Planning & Zoning Board Staff Report for October 1, 2019 Meeting

SPR #19-12. Request of Majid Kalaghchi for: Approval to construct a new, two-story, 4,393 square foot, single-family home located at 470 Fairfax Avenue on the Howell Creek Canal, zoned R-1AA.

SPR #19-13. Request of Charles Clayton Construction for: Approval to construct a new, two-story, 16,036 square foot, single-family home located at 115 Palmer Avenue on Lake Maitland, zoned R-1AAA.

C102
DETAILED SITE PLAN

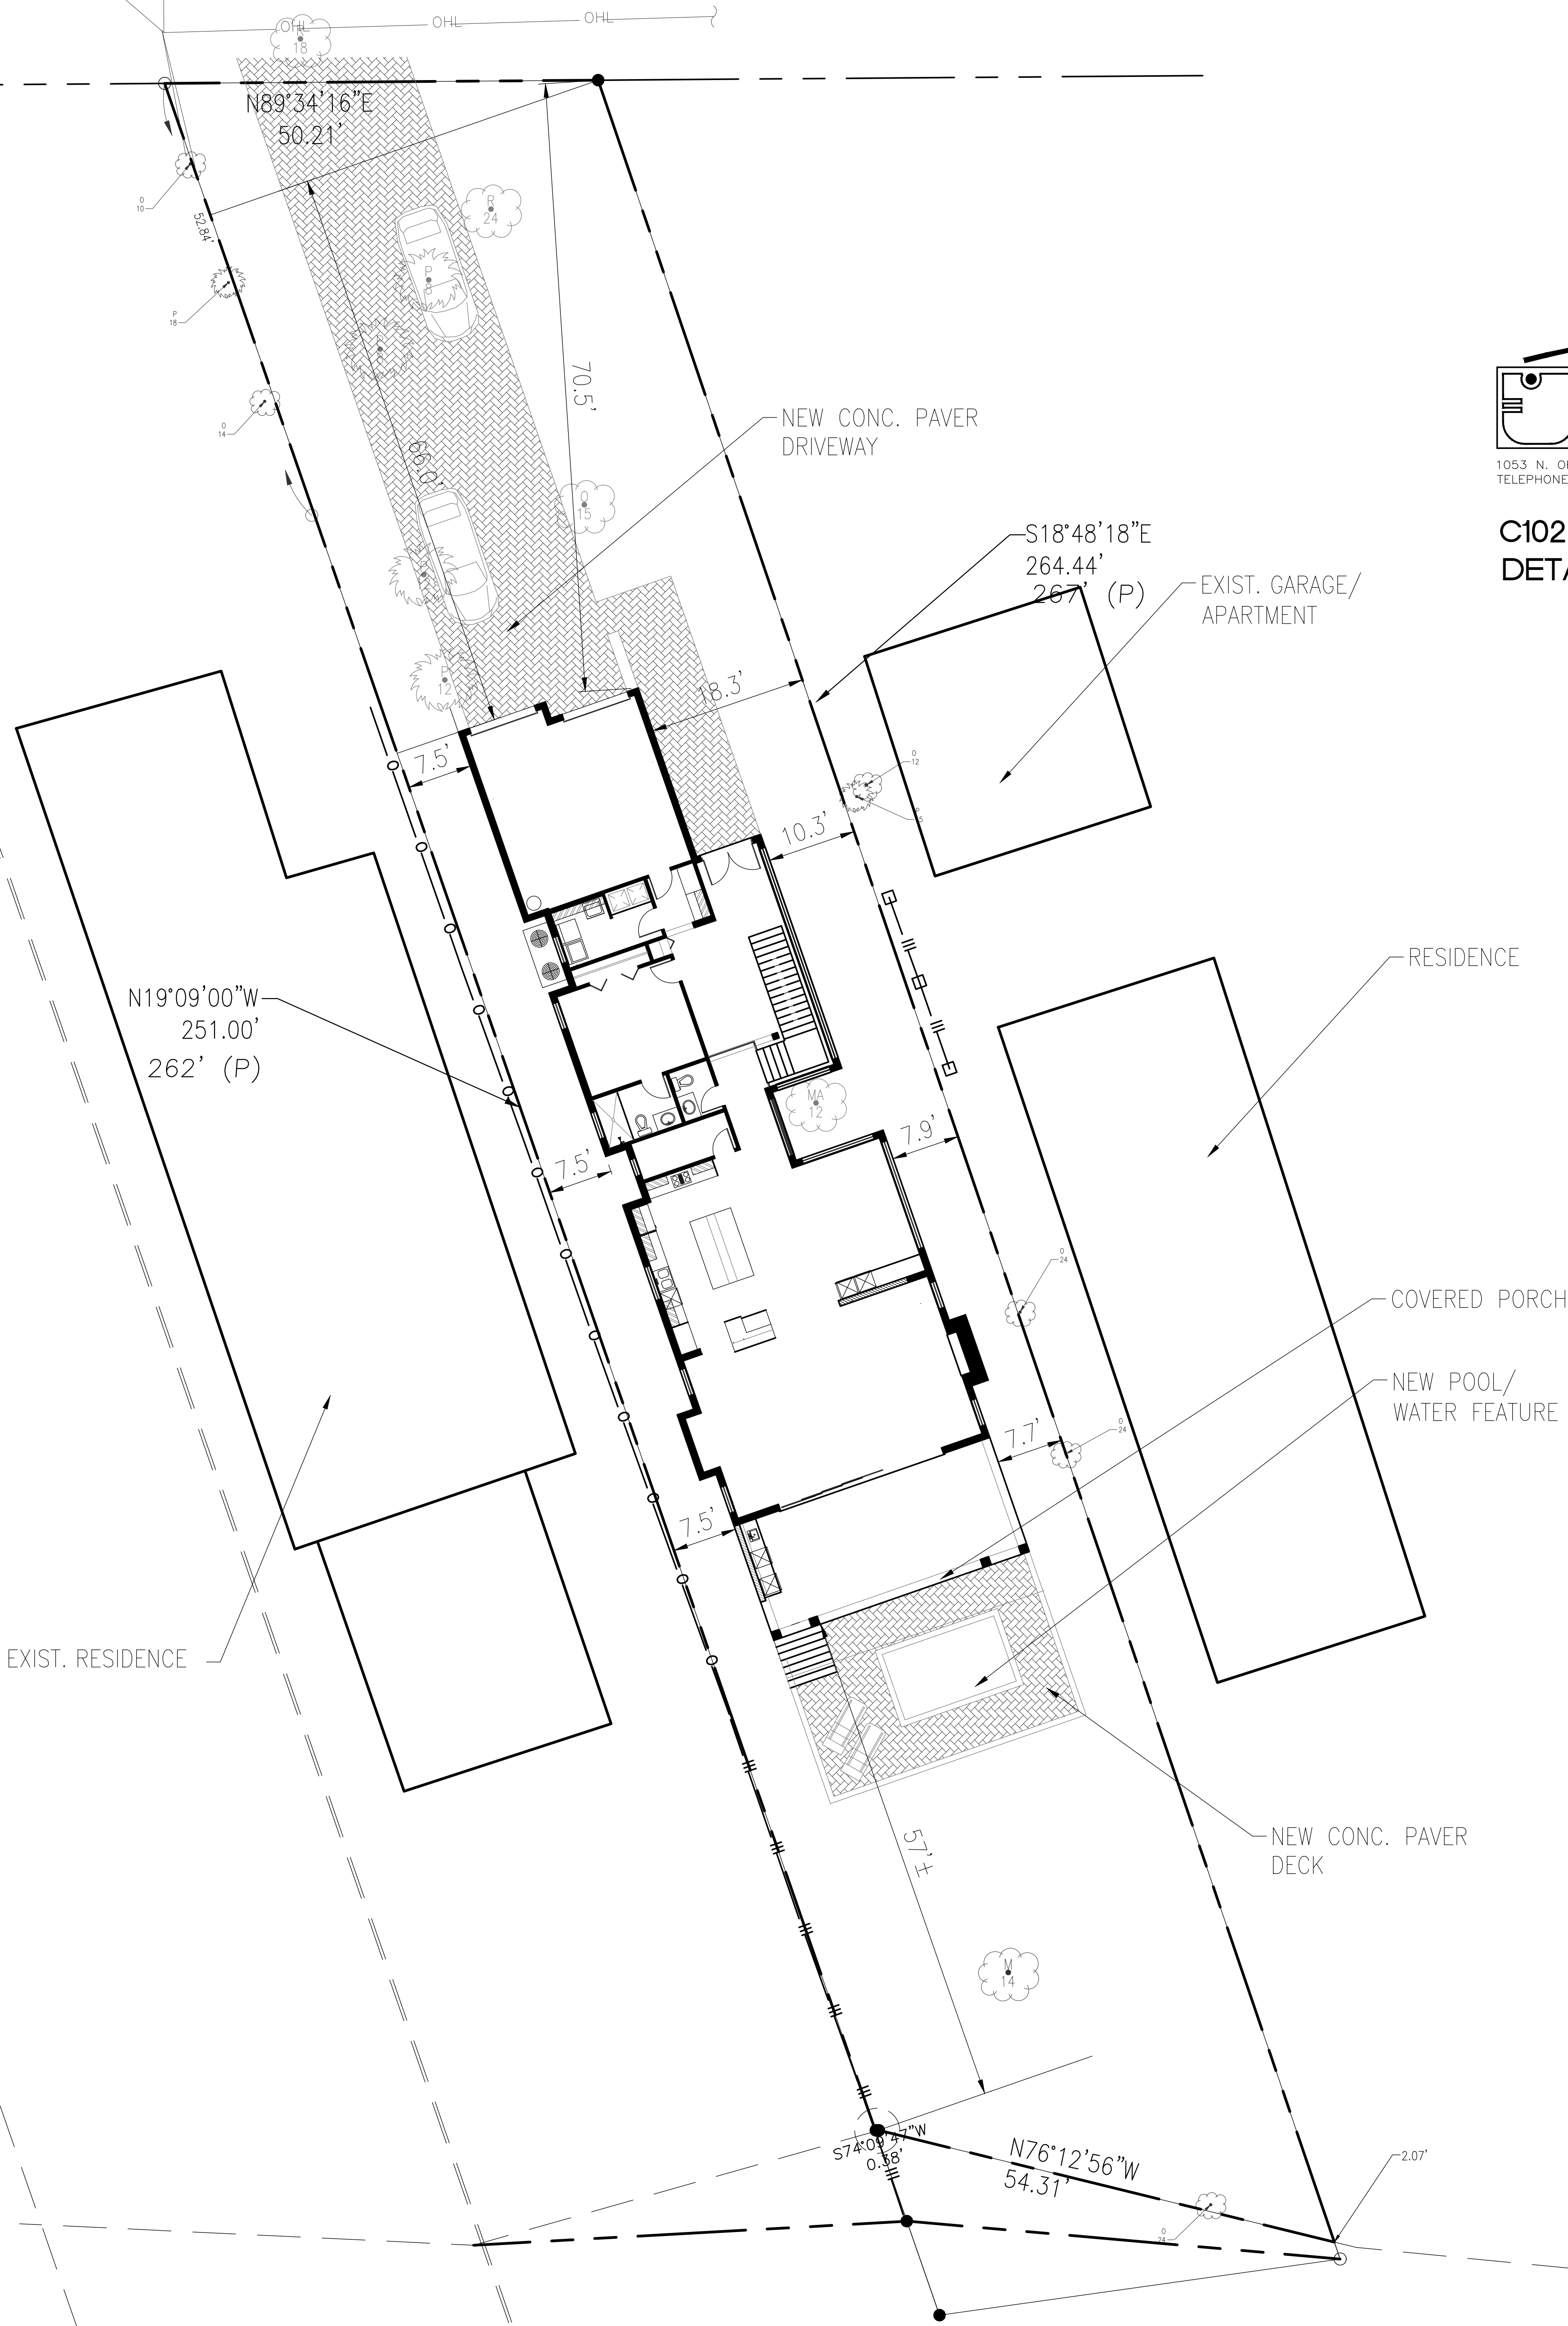
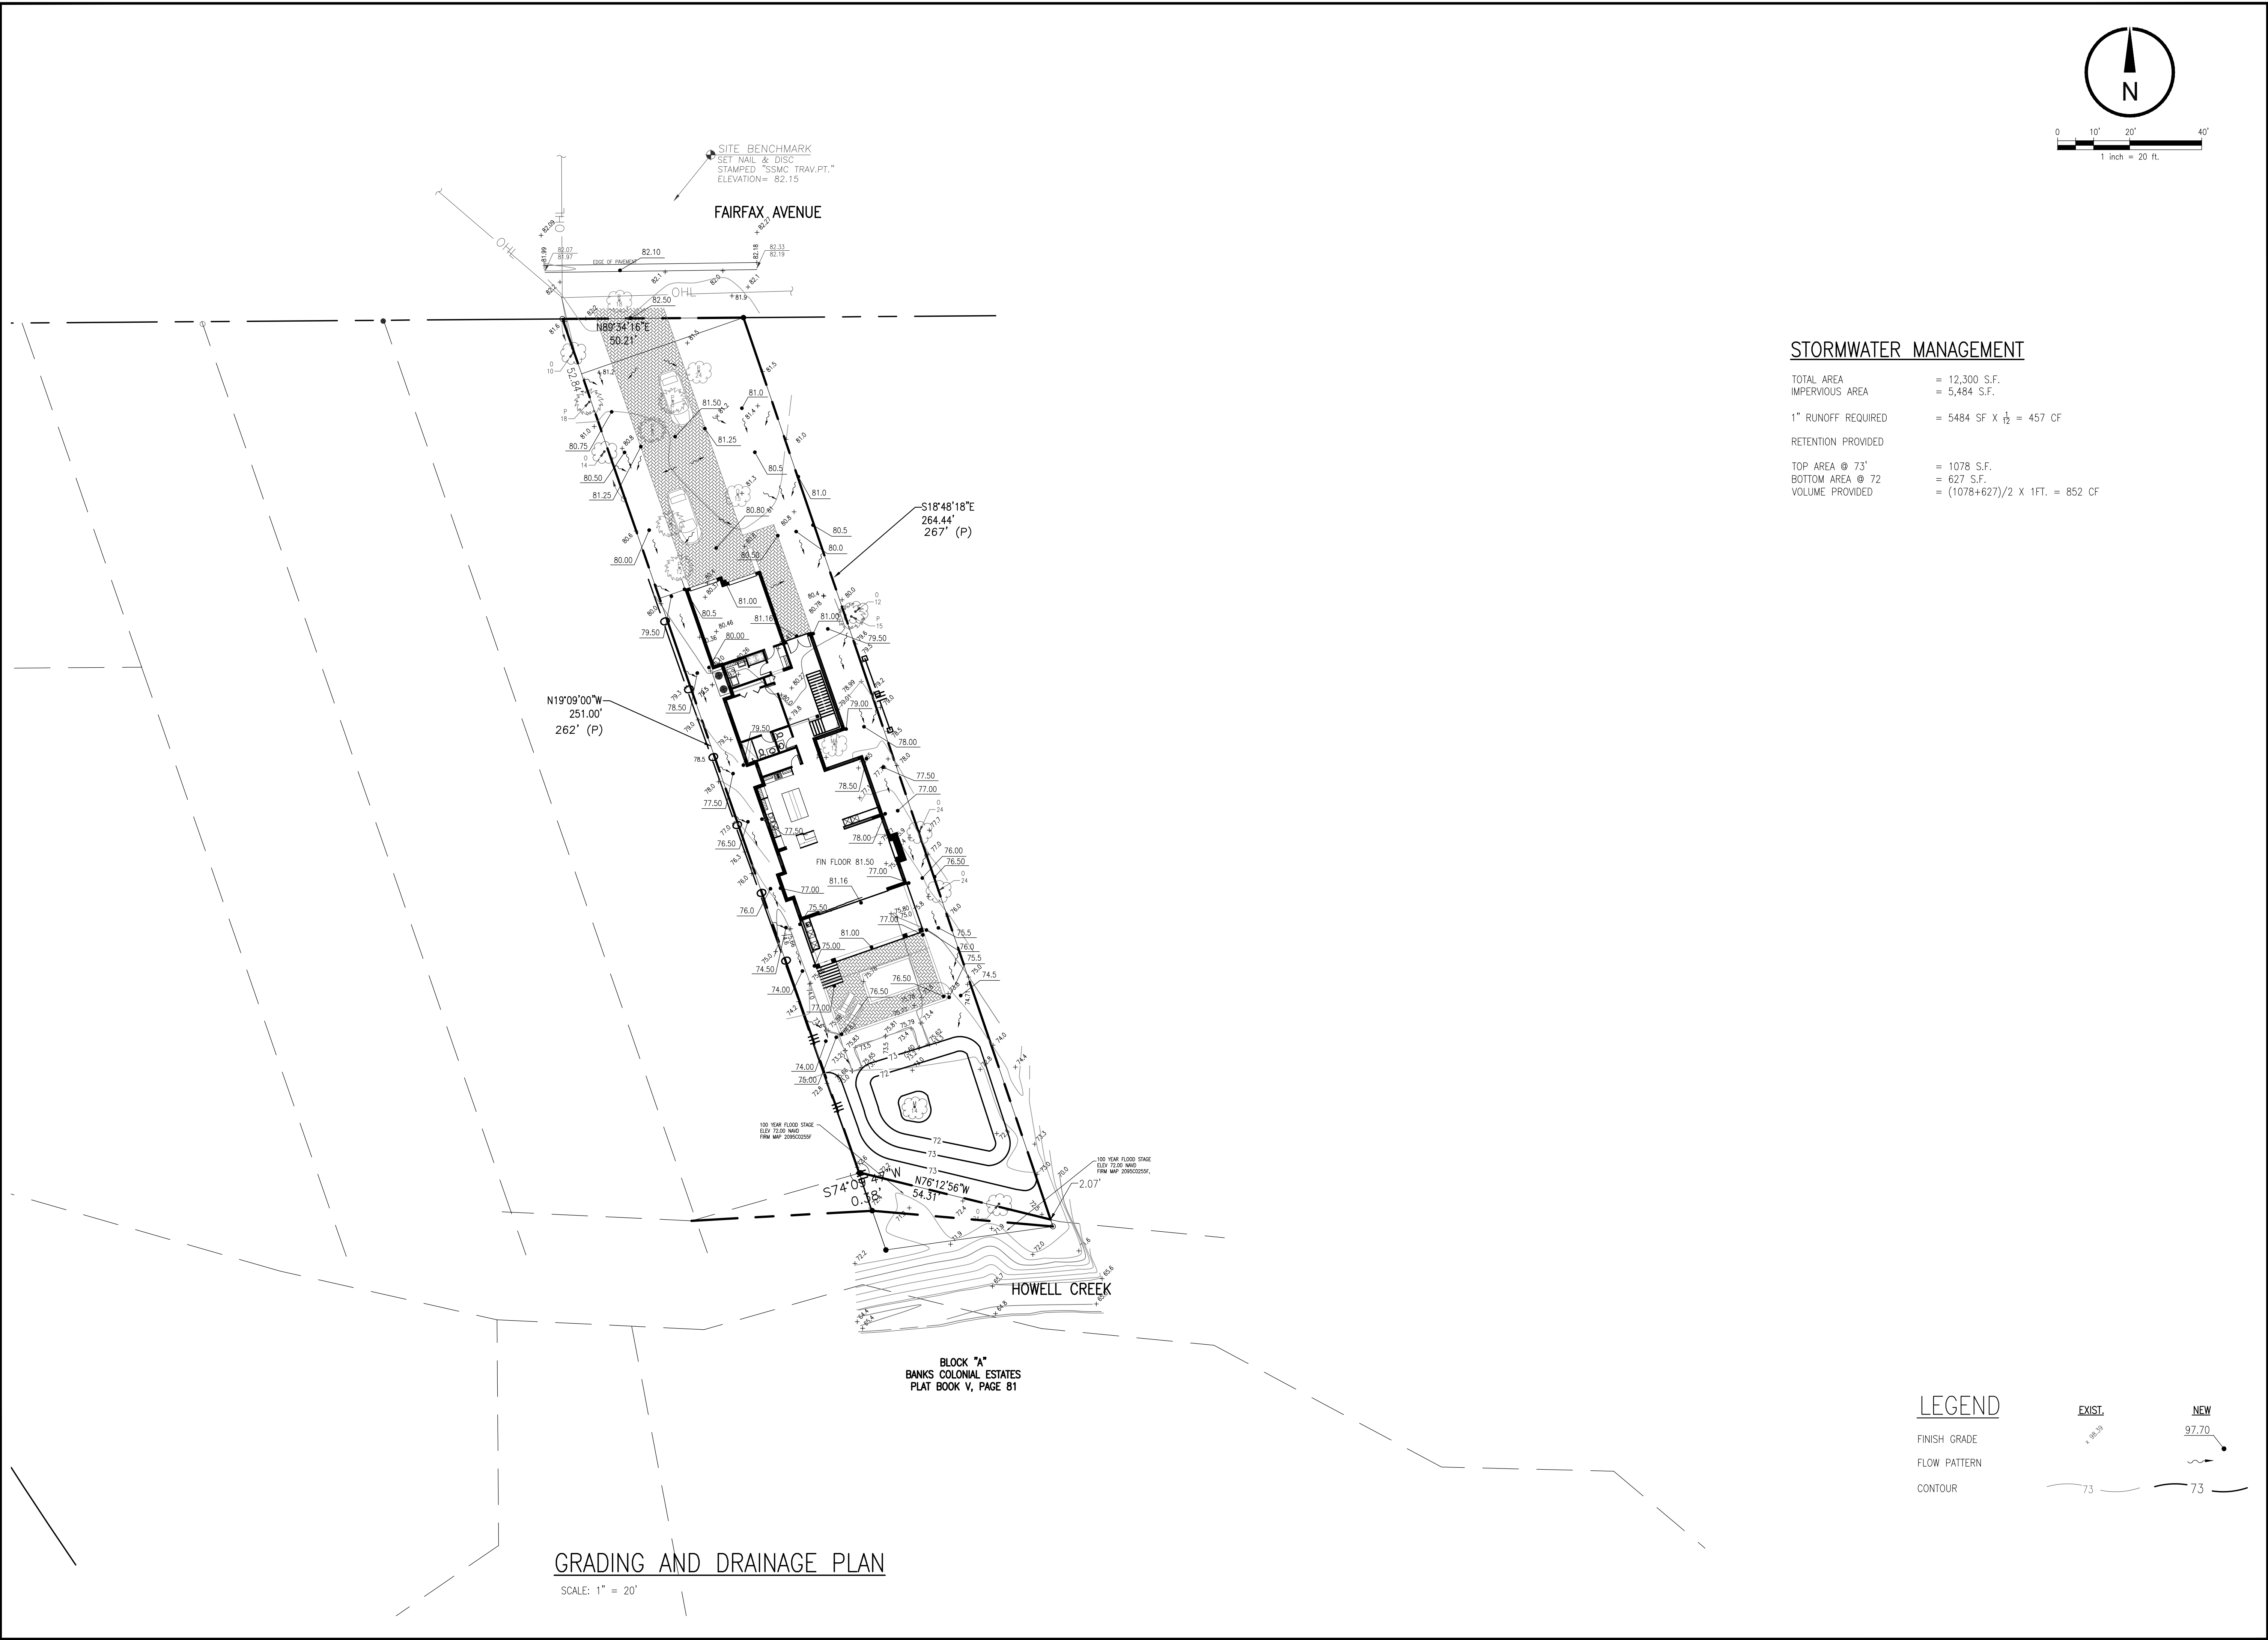
The code limits walls and swimming pool decks facing the canal in excess of three feet in height. This lot does have some grade drop from the street front to the canal, but the pool deck height does not exceed the three foot height code maximum.

The purpose and intent of the lakefront/canal front lots section of the code is to ensure that the views of the canal from adjoining properties will not be unduly impaired by new houses, additions, second story additions, etc. In order to achieve this, the code states that the lakefront/canal front setback shall be the average established by the adjacent waterfront properties within 200 feet of the subject property, or 50 feet, whichever is greater. However, the P&Z Board does have the authority to approve setbacks less than the average determined, or impose more restrictive setbacks. Staff has determined that the average waterfront setback is approximately 57 feet from the canal, and the applicant is adhering to this 57 foot setback.

The code requires retention of stormwater so that stormwater flowing over a waterfront lawn area does not carry with it into the canal or chain of lakes any fertilizers, herbicides, or other chemicals that affect the water quality of our community's most precious assets. The amount of impervious surface on the lot determines the depth/size of the retention needed. The applicant is proposing a stormwater swale near the canal that is sized to meet the City's code requirements.
